VALUE ENGINEERING CHANGE PROPOSAL MISSOURI DEPARTMENT OF TRANSPORTATION

Contract ID 091218-605 Job No. J6P2139

091218-605
J6P2139
Rte 47
Franklin County

Revised VE

NEW TYPICAL PROPOSAL RTE 47

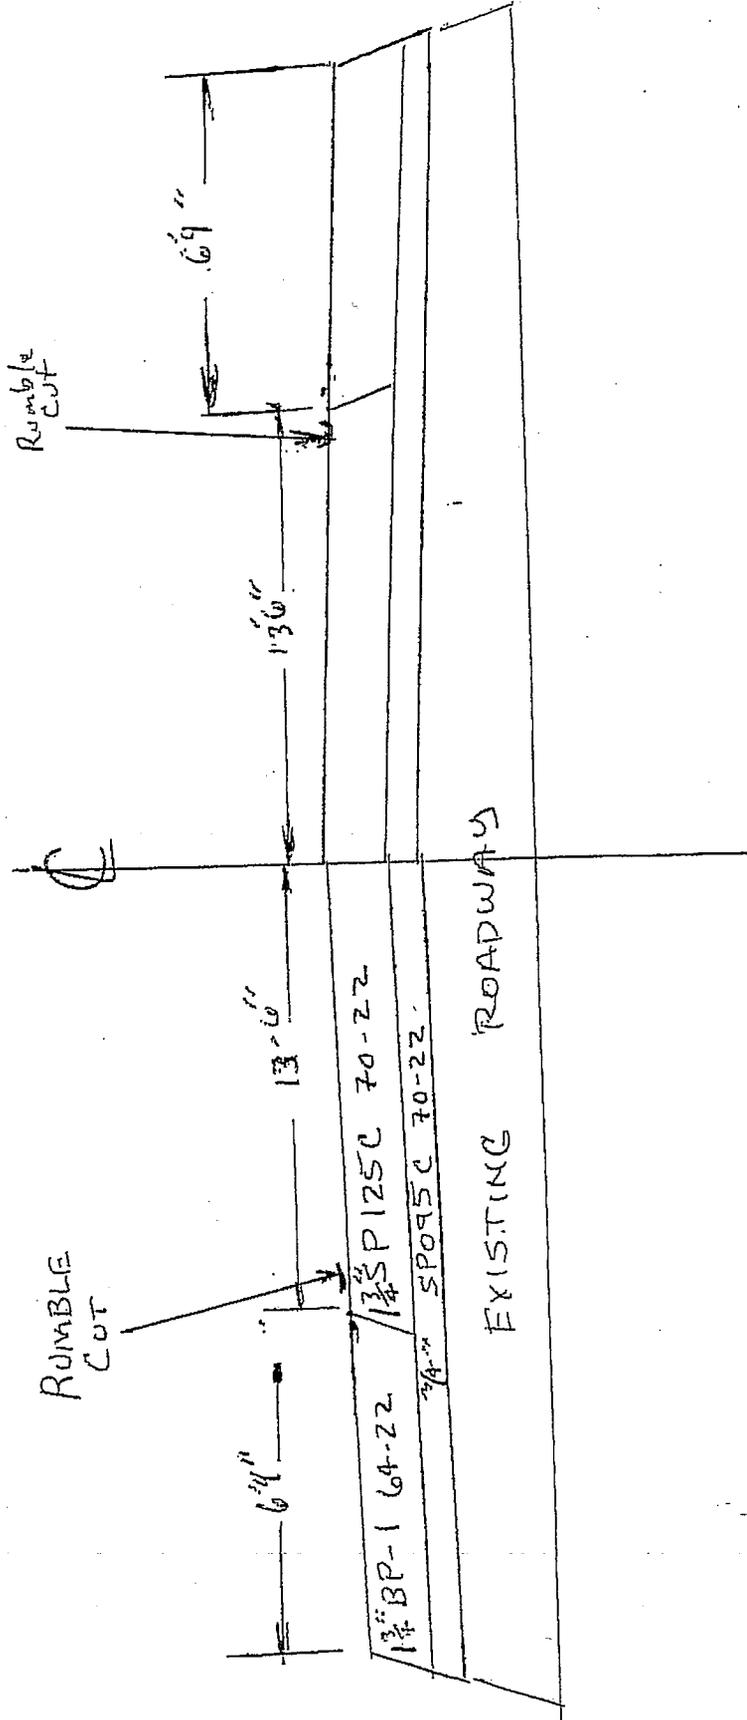
Propose to substitute the asphalt on the shoulder and side roads from a SP125CLP mix to a BP-1 mix.

The previous submittal proposed a switch on the surface mix type. At this time we are going to use the original mix design with SP125CLP for the mainline pavement and switch the shoulder mix to BP-1. This concept is considered to be a practical design change and would be split out at 25%/75% savings. Please review the revised typical section and calculation sheets.

I recommend approval of PDVECP#1. The Franklin County Area Team, District 6 Materials, and the Support Center all concur with utilizing BP-1 on the shoulders in lieu of the original plan SP125CLP as long as the construction joint is outside the rumble stripe - see attached typical section (13'6" from centerline). This PDVECP#1 will result in a significant cost savings to MoDOT.

We are providing a revised typical section and calculation for the new VE concept. The main savings is still provided by substituting BP-1 for the SP125CLP on the shoulders and entrances. See Below

- Change the asphalt on the shoulders and entrances from SP125CLP 70-22 @ \$ 67.94 to BP-1 64-22 @ \$ 58.25.

I AM IN AGREEMENT WITH THE ABOVE AND RECOMMEND APPROVAL.
CONTRACTOR IS TO FOLLOW ALL THE SPECIFICATIONS FOR PLACEMENT OF BP-1 MIX
AND PROVIDE ACCEPTABLE RESULTS IN THE FIELD.

Approved on the basis of the district's comments. 3/10/2010 Denis Glascock
